RFI

RFI #: 15
 Date: 12/14/2011
 Job: EB-02 Keller Springs Lots
 Phone: 877-777-5115

Subject: BBQ handle height and countertop

F GAS GRILL IN SPLIT FACE BLOCK ENCLOSURE
 3/8" = 1'-0"

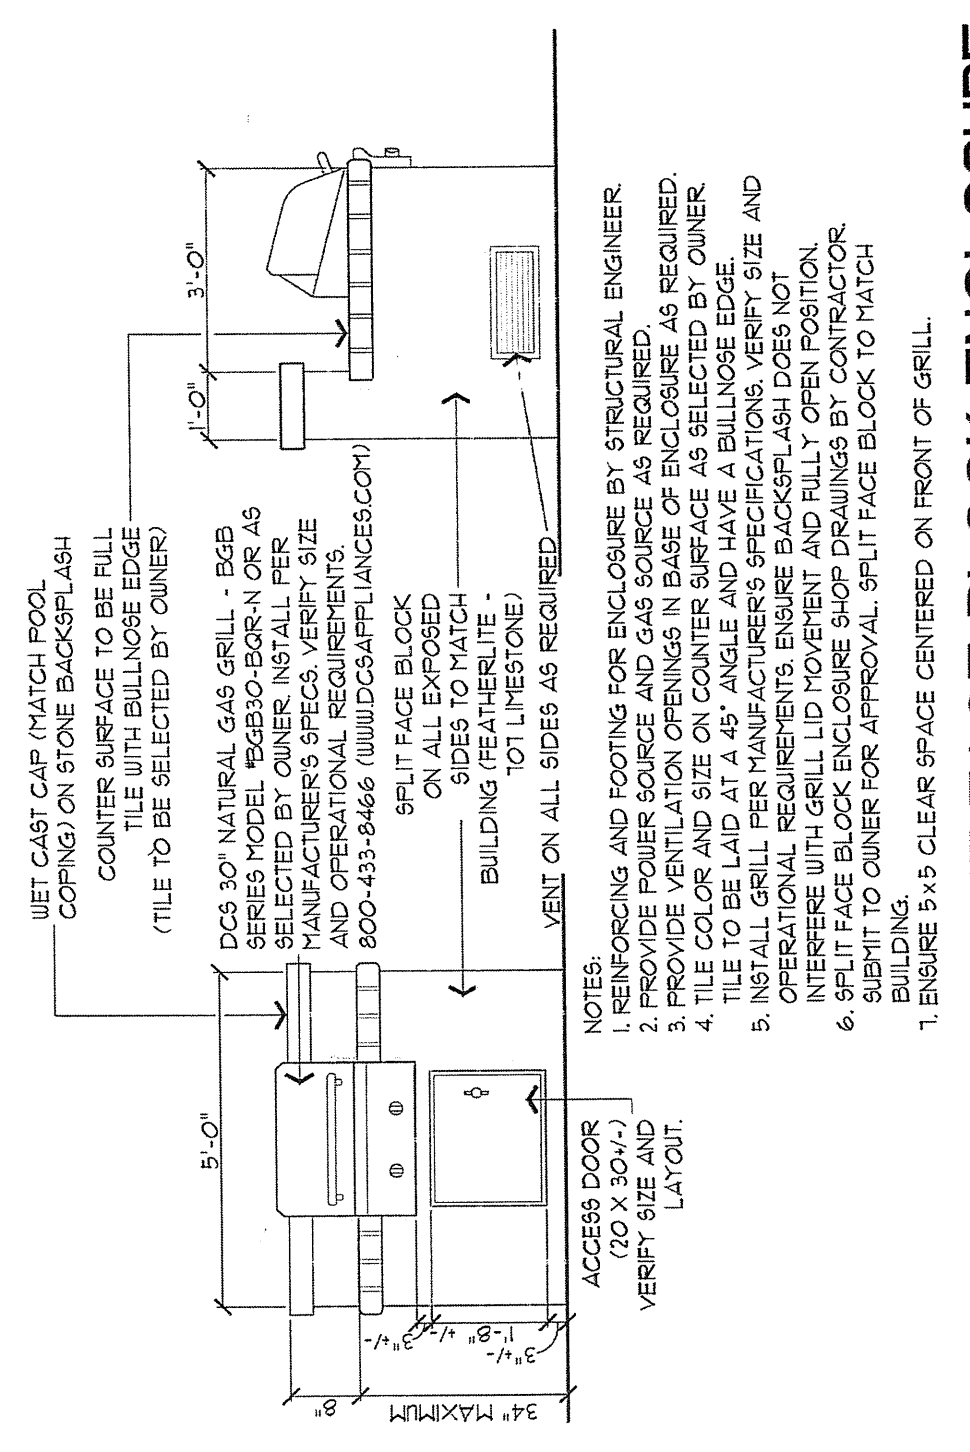
Request: Date Required: 12/21/2011
 Please confirm height of the handle of the BBQ grill is it compliant with ADA?
 Also the countertop is called out at 36" should it be 34 1/2" to be compliant with ADA?
 Requested by: Bryan Pickler
 Embrey Partners, Ltd.

Response:
 WE DO NOT KNOW HOW ANY GRILL LID WOULD BE COMPLIANT WITH ADA. BBQ
 REGULATIONS WAS GOING TO ASK THE QUESTION TO THE H.J.D REVIEWER. WE HAVE NOT
 RECEIVED A RESPONSE FROM THE REVIEWER AT THIS TIME.
 THE GRILL ENCLOSURE COUNTERTOP SHOULD BE MAXIMUM 34" HEIGHT TO BE
 COMPLIANT WITH ADA. OUR FURNISH INCLUDED ALL OUT-OF-DATE DETAILS THAT
 HAS SINCE BEEN REVISED. THE UPDATED DETAIL IS ATTACHED.
 Answered by: DAVE ARTHUR
 Company: ENVIRO DESIGN Date: 12-16-2011
